MIL-M-28787/327
AMENDMENT 1
16 December 1992

MILITARY SPECIFICATION

MODULES, STANDARD ELECTRONIC

COMPARATOR, MAGNITUDE, DIGITAL, KEY CODE JHB

FIGURE 5. Isolation test circuit for table III.

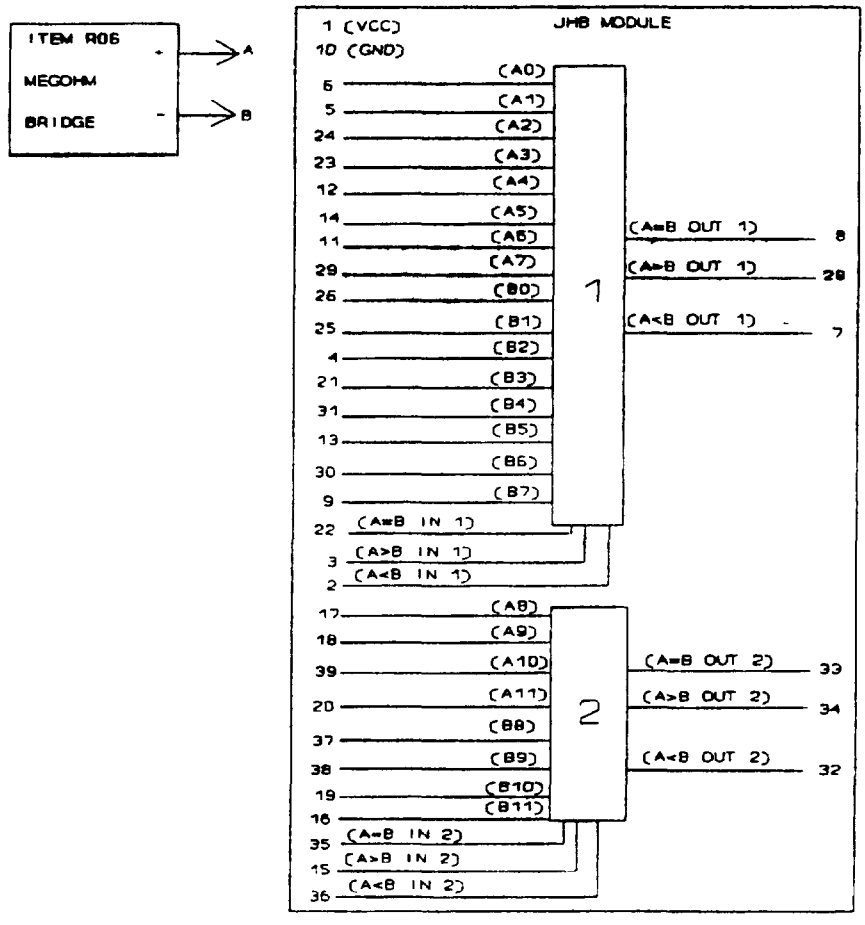
FIGURE 5: Delete and substitute new figure 5 as printed on page 3 of this amendment.

1. For test condition A1, penetrate the anodized finish on the module frame with a sharply pointed probe connected to the negative terminal.

2. For test condition A1, the megohm bridge voltage shall be 100 ± 10 Vdc.

3. For test condition A2, the megohm bridge voltage shall be 30 ± 3 Vdc.

FIGURE 21. Input capacitance test circuit for table XVI.

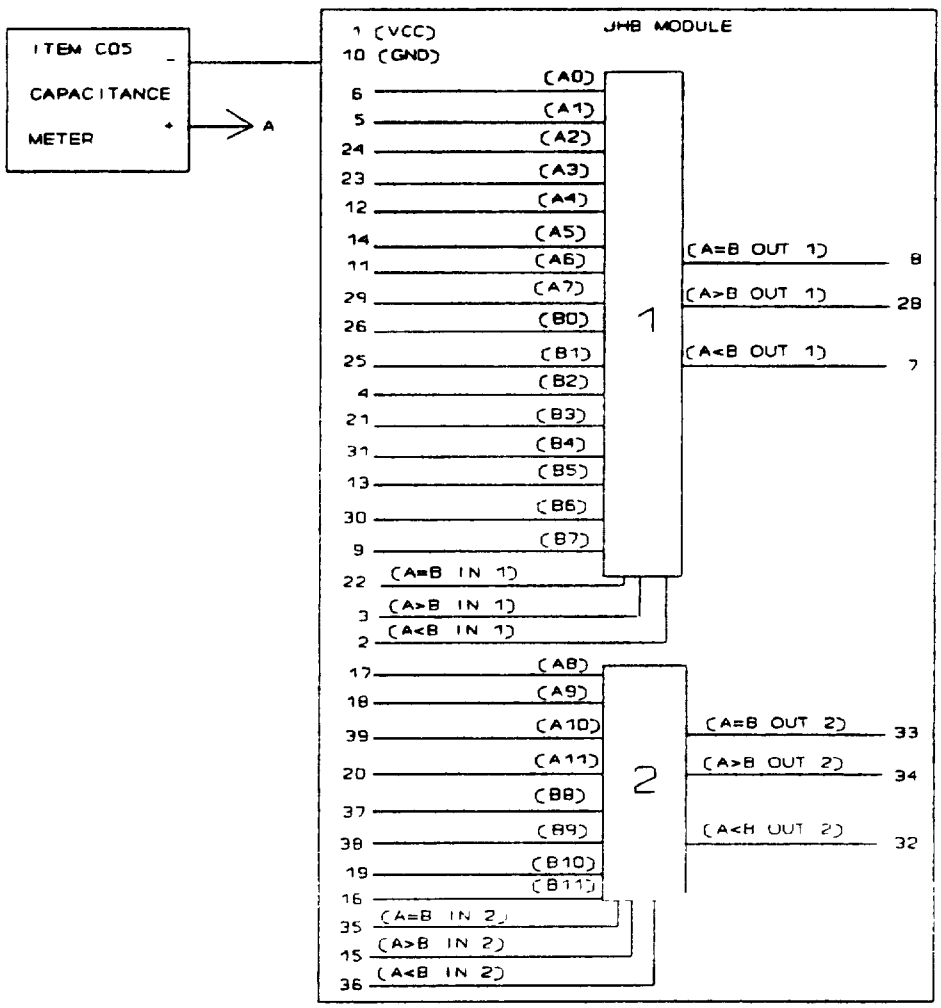
FIGURE 21: Delete and substitute new figure 21 as printed on page 4 of this amendment.

1. Do not attach test connector or wires to any of the module pins other than pin 10 and the pin under test. Stray capacitance added to other pins may affect the readings.

2. Null out the effects of the test leads prior to connecting to the module.
